**Amendments to the Drawings:**

**REMARKS**

The Final Office Action mailed March 2, 2004, has been received and reviewed. Claims 1, 3, 4, and 18 through 26 are currently pending in the application. Claims 1, 3, 4, and 18 through 26 stand rejected. Applicants propose to amend claims 1, 3, 4, 20, 22, 23 and 25, and respectfully request reconsideration of the application as proposed to be amended herein.

**Fig. 2**

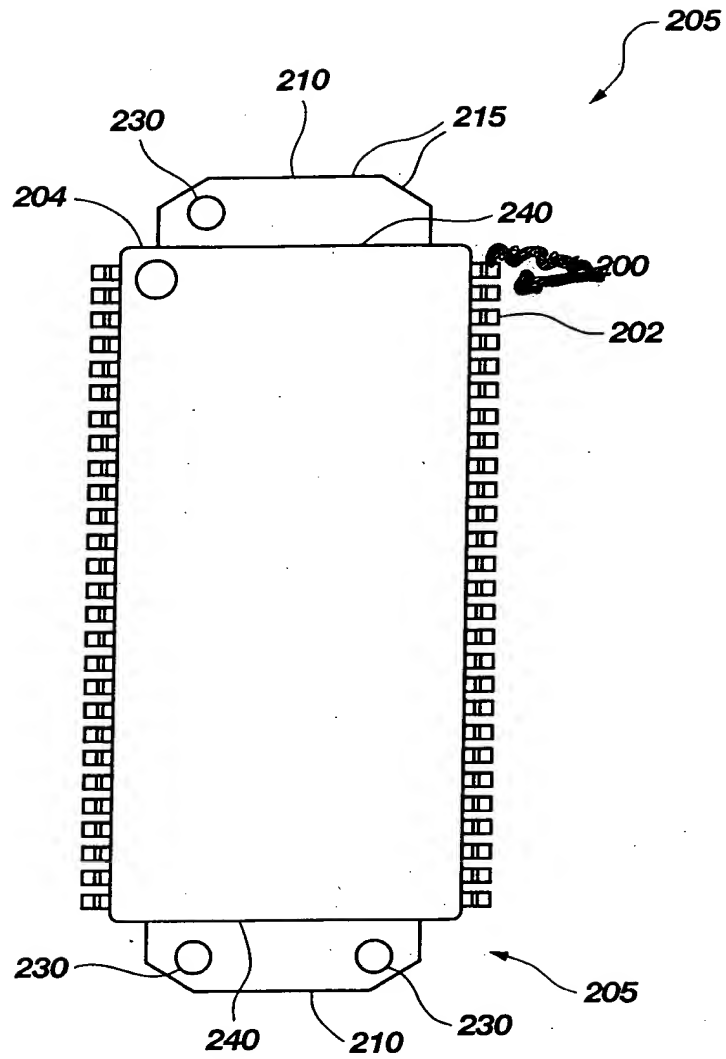
The Examiner objects to the drawings as failing to comply with 37 CFR 1.84(p)(5) because FIG. 2 does not include the reference sign "200." Applicants note that FIG. 2 *does* include the reference sign "200" and, that, in a previously submitted Amendment Applicants amended the lead line associated therewith for purposes of clarity.

Applicants submit, herewith, replacement FIGS. 2, 4A and 4B which incorporate drawing changes already submitted (see Amendments mailed on May 3, 2003, and November 17, 2003 – copies of previously submitted FIGS. 2 and 4A and 4B showing changes marked in red are also included herewith for the convenience of the Examiner).

Fig. 4A

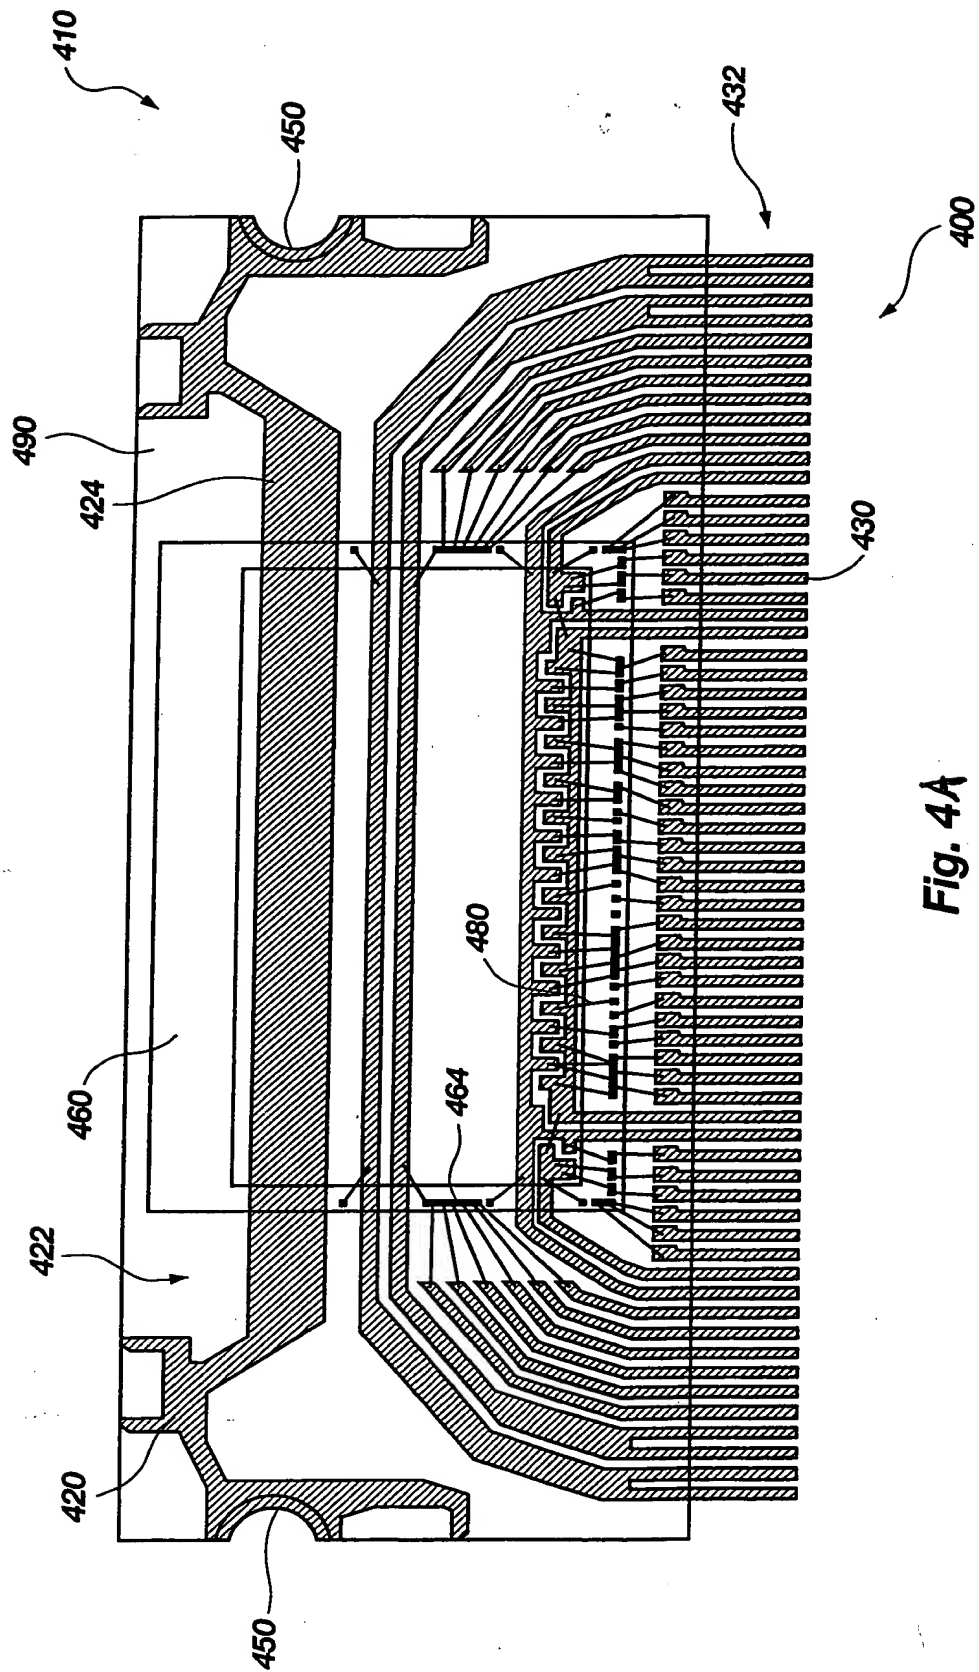
The attached sheets of drawings include FIGS. 2, 4A and 4B which replace the original sheets including FIGS. 2 and 4 and in accordance with previously submitted drawing revisions (for the Examiner's convenience, previously submitted FIGS. 2, 4A and 4B, with changes shown in red, are also included). No new matter has been added.
